Beaver Valley Power Station

June 29, 2015
L-15-202

Response to Request for Additional Information on Expedited Seismic Evaluation Process (ESEP) Reports and Seismic Hazard and Screening Reports Submitted Pursuant to 10 CFR 50.54(f) Regarding Recommendation 2.1 of the Near-Term Task Force (NTTF) Review of Insights from the Fukushima Dai-ichi Accident (TAC Nos. MF5223, MF5224, MF3726, and MF3727)

Response to NRC RAI Control Point GMRS and Control Point Hazard Curves Beaver Valley Power Station

FIGURE 1
0.5-HZ SA MEAN AND FRACTILE HAZARD CURVES FOR BVPS SITE AT
EL 681 (BASE OF BVPS-1 AND BVPS-2 REACTOR BUILDING FOUNDATION)

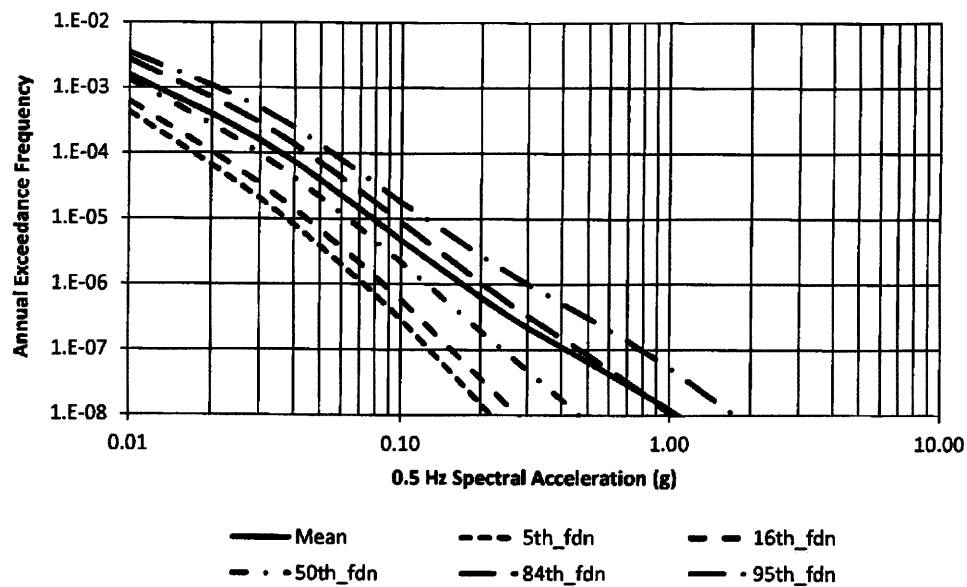
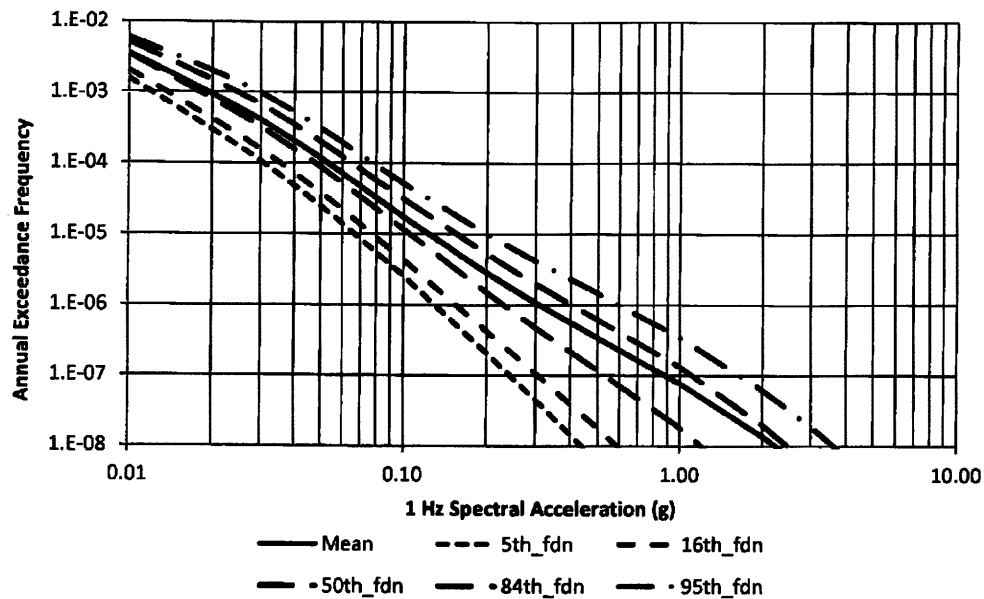
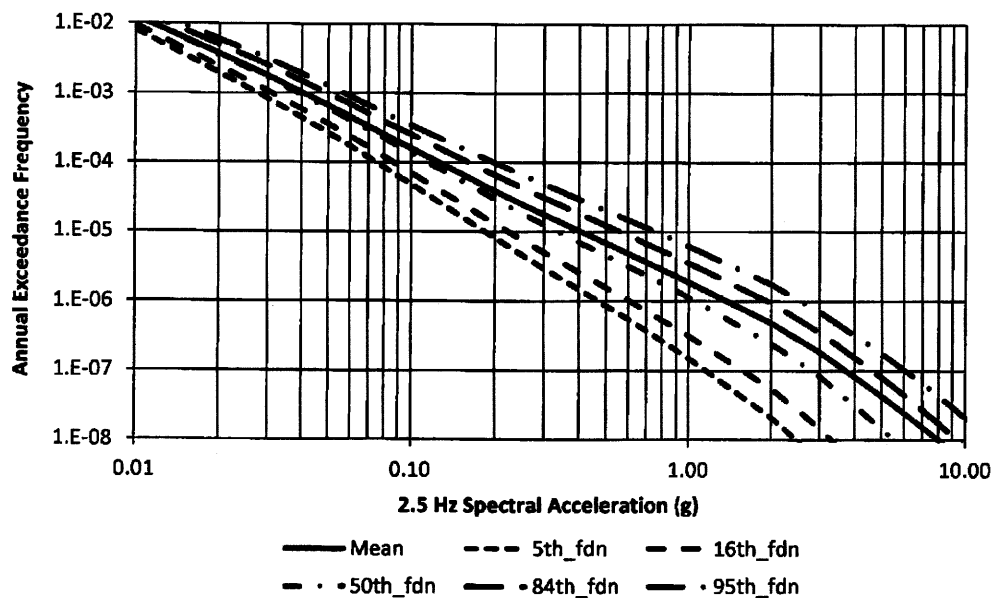
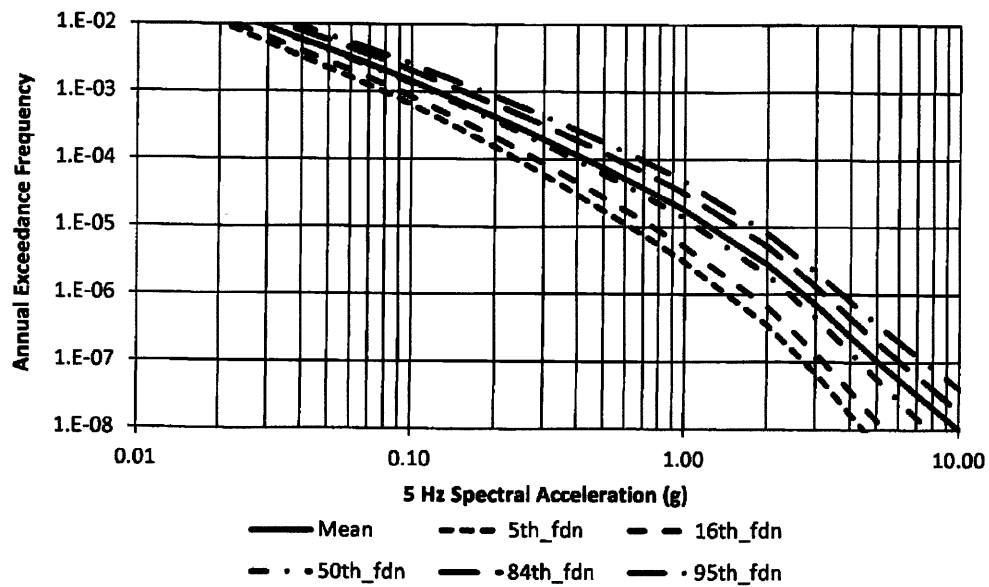
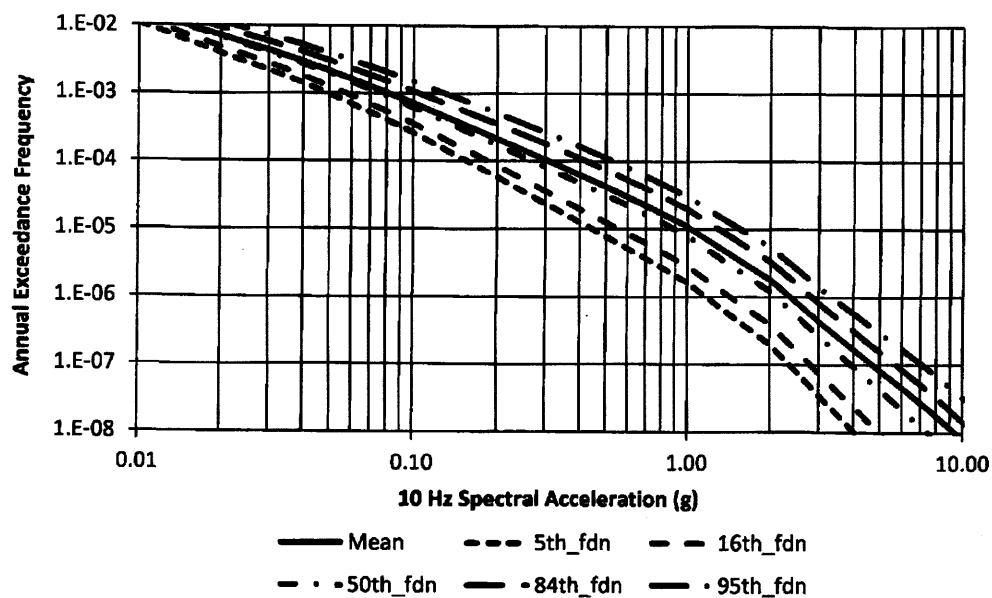
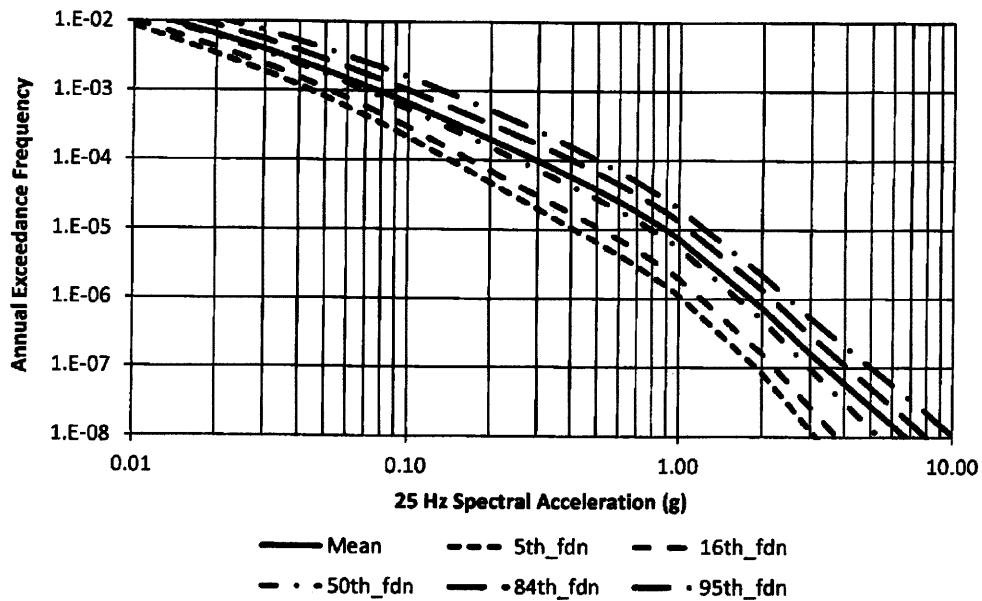
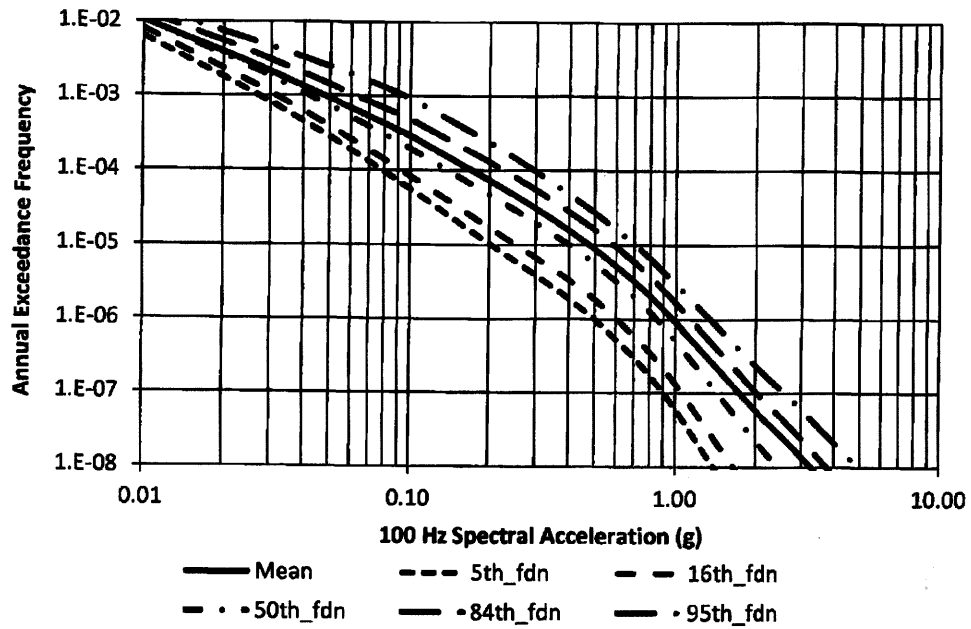
Provide: Control point hazard curves at the Ground Motion Response Spectrum (GMRS) level and the GMRS itself.

The requested information is provided in the enclosed report, *Response to NRC RAI Control Point GMRS and Control Point Hazard Curves Beaver Valley Power Station*.

The above procedure is executed to generate the mean hazard curve and the fractiles at EL 681. *Figures 1 through 7* present the mean and fractile hazard curves at EL 681 for spectral frequencies of 0.5 Hz, 1 Hz, 2.5 Hz, 5 Hz, 10 Hz, 25 Hz, and 100 Hz, respectively. *Tables 7 through 13* present numerical values of the mean hazard curve and the fractiles of the hazard distribution. The entries, which are labeled as “----” represent ground motions that are not realizable for a given fractile.
